ADDENDUM NO. 02
City of Camas
WWTP Headworks and Primary Clarifier Improvements
March 26, 2024

The following addendum is hereby issued and made a part of the Plans and Specifications for the **WWTP Headworks and Primary Clarifier Improvements** project.

This Addendum No. 02 is hereby made a part of and incorporated into that certain CONTRACT DOCUMENTS FOR THE CITY OF CAMAS **WWTP Headworks and Primary Clarifier Improvements** project. Notice is hereby given that the Contract Documents for the subject project are amended/clarified as follows:

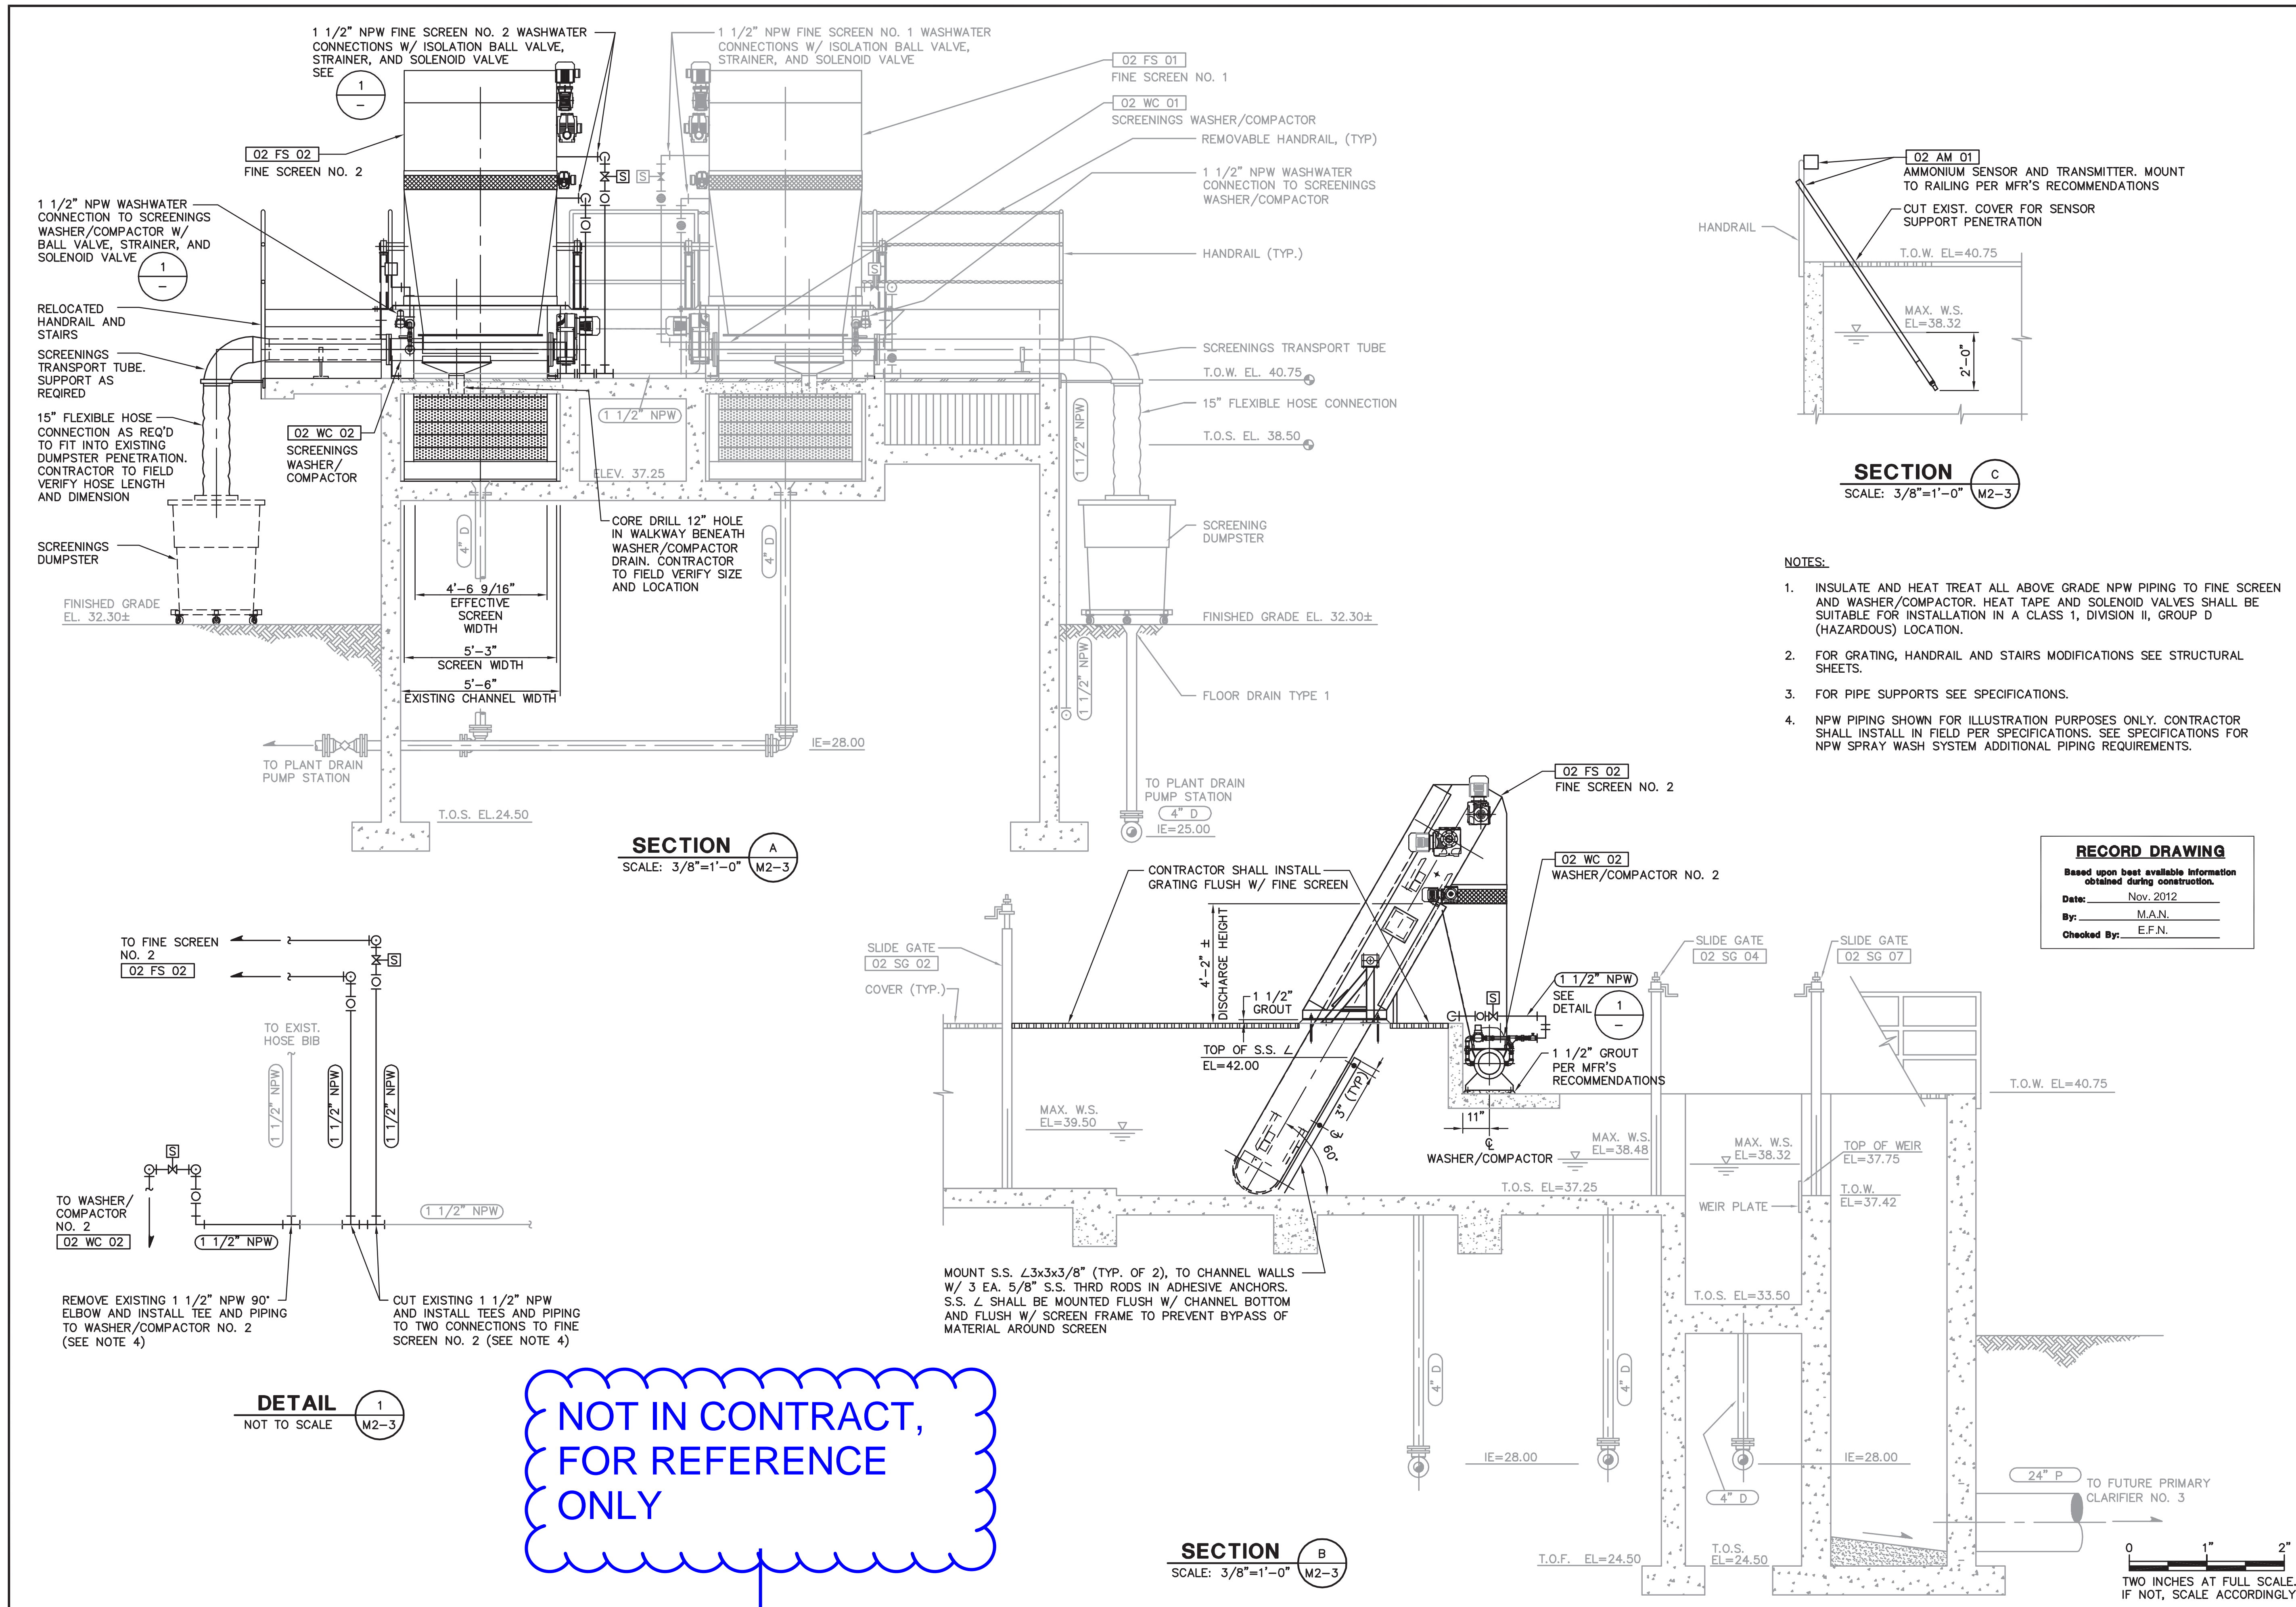
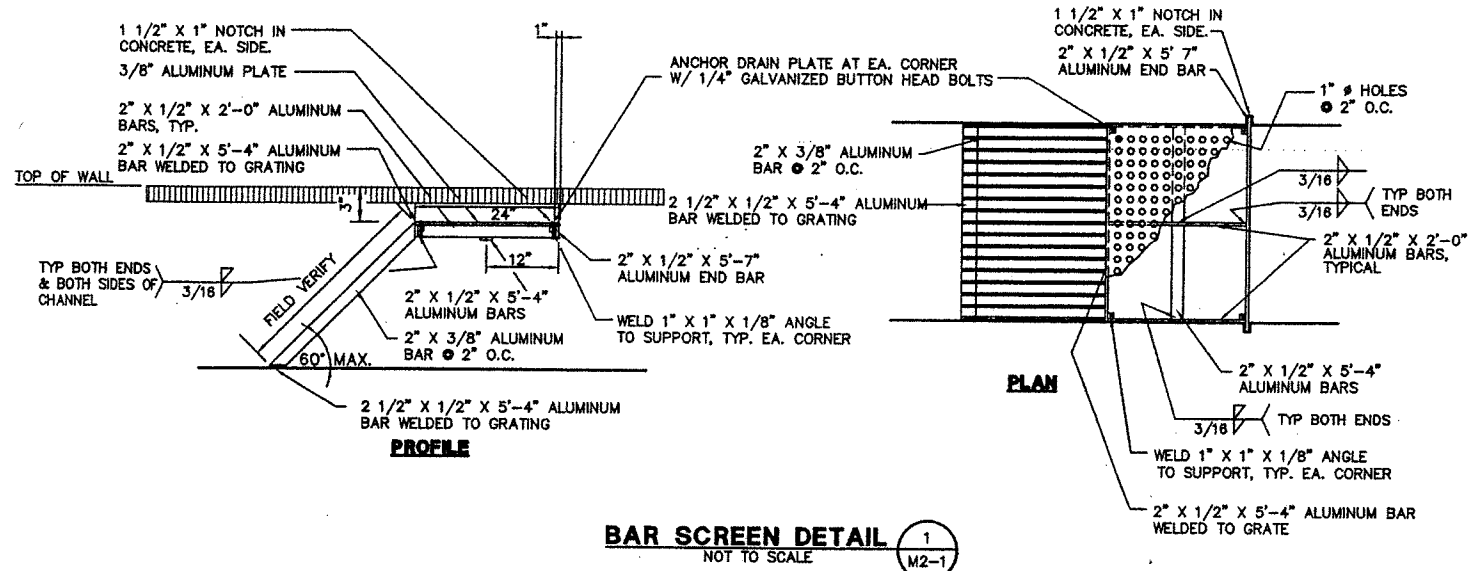
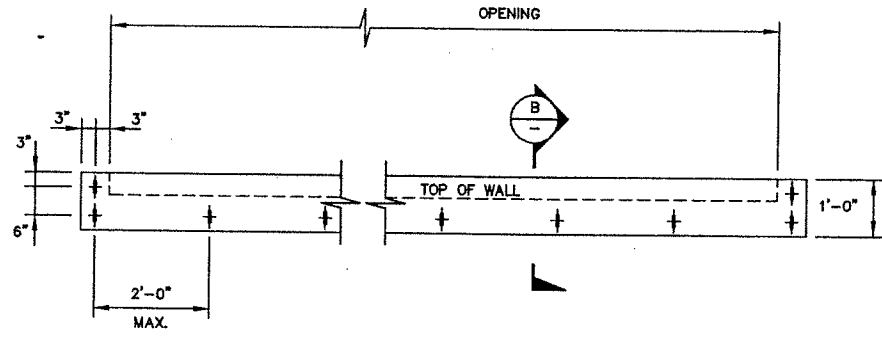
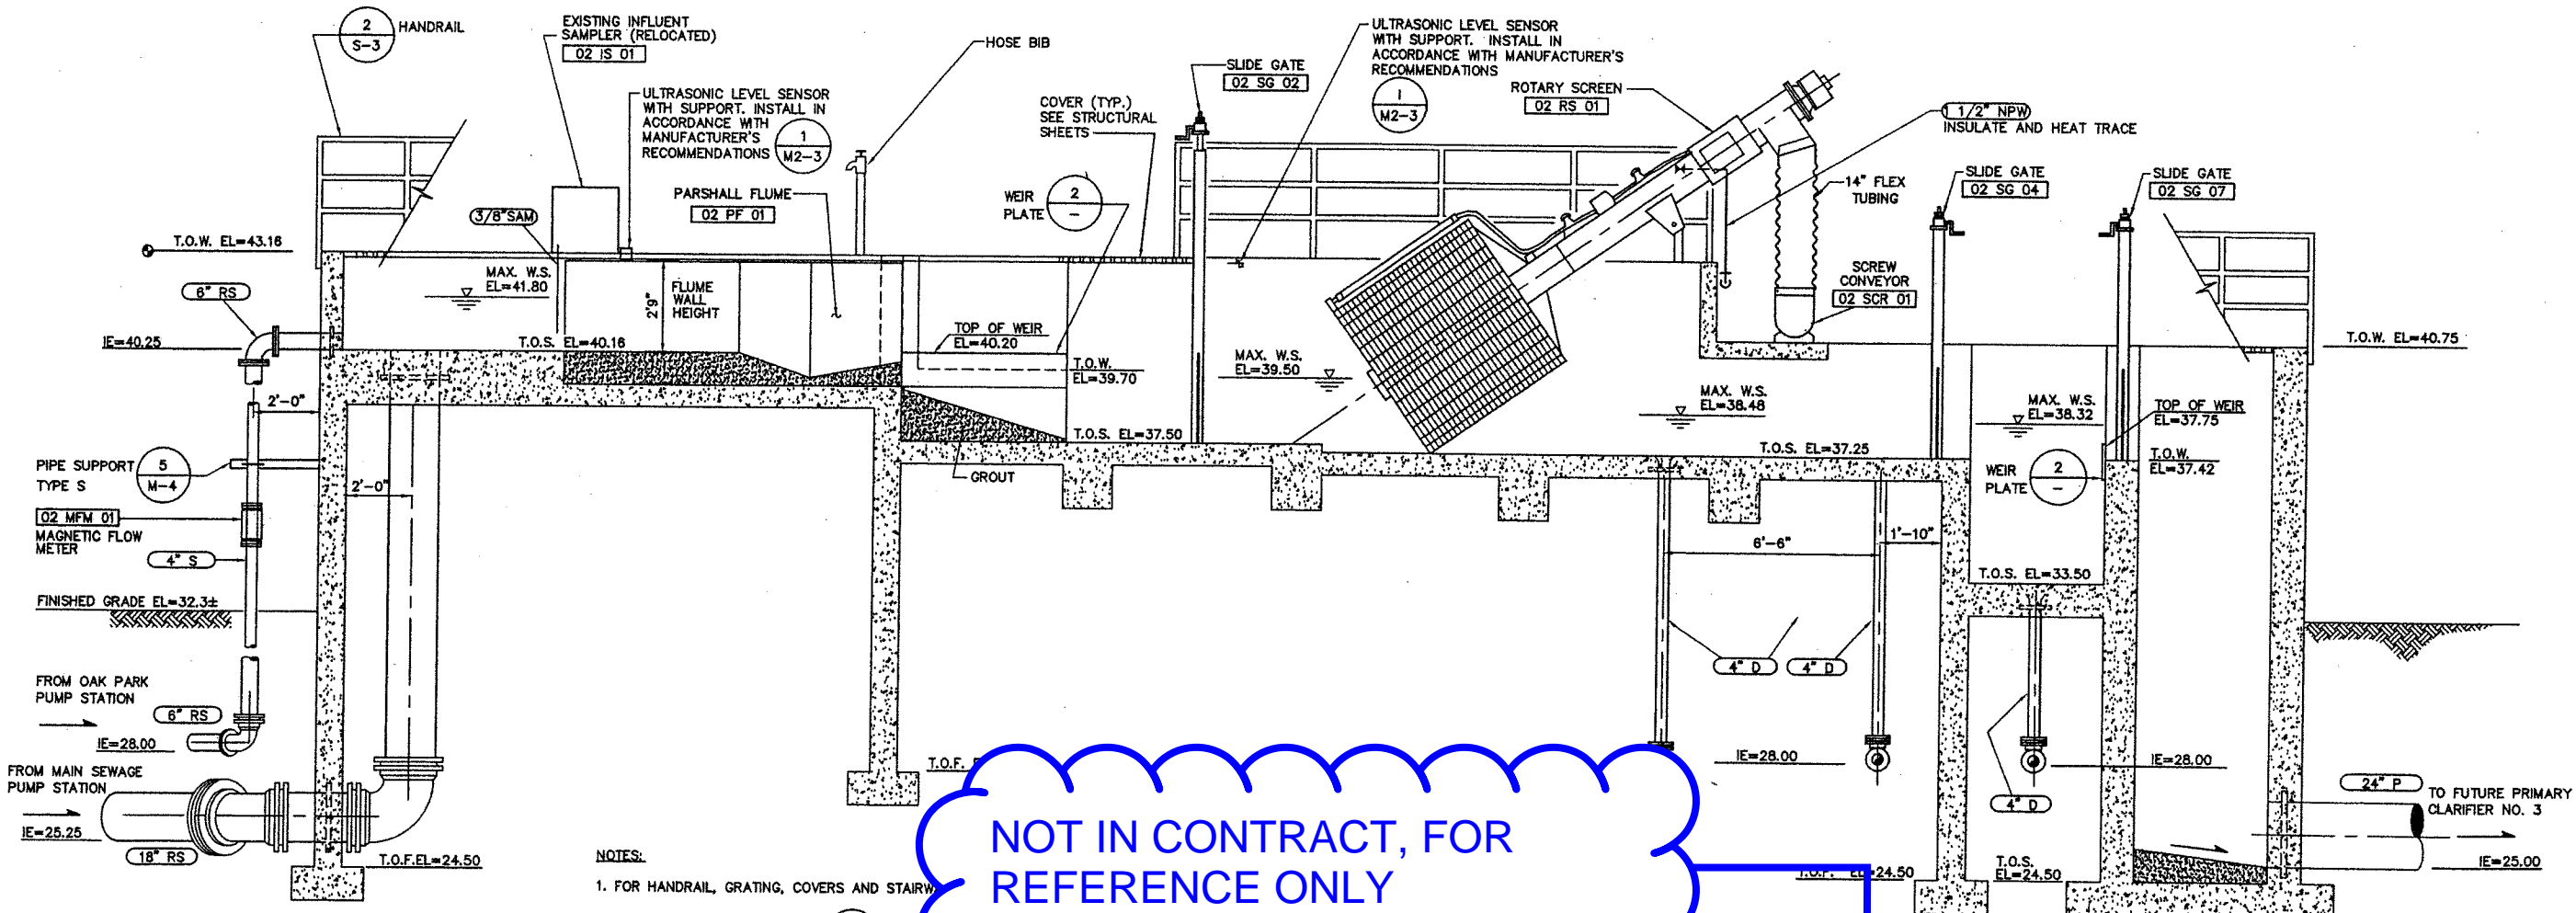
1. Please provide top of wall elevation and invert elevation.
2. Can you confirm need for yoke mounted pedestal vs. a standard self-contained guide.
3. Please confirm if manual or electric operator is needed.
4. If an electric operator is needed, please provide a specification for this.

1. The wall elevations are as shown on the attached drawing. The attached drawing items are part of a previous project and the drawing is provided for reference only.
2. There is grating or plating above all the channels on the headworks. It is intended that the pedestal is mounted at the top of wall alone.
3. The slide gates show on drawing M2003 are hand wheel operated. No electric actuator is to be provided.
4. The drawing M2004 shows the correct gate dimensions, but for clarification, gates are 24”H x 36”W for note 2.
5. Drawing S0004 is shown for reference only, actual opening/gate dimensions are depicted elsewhere. The opening size must be confirmed with slide gate shop drawings.
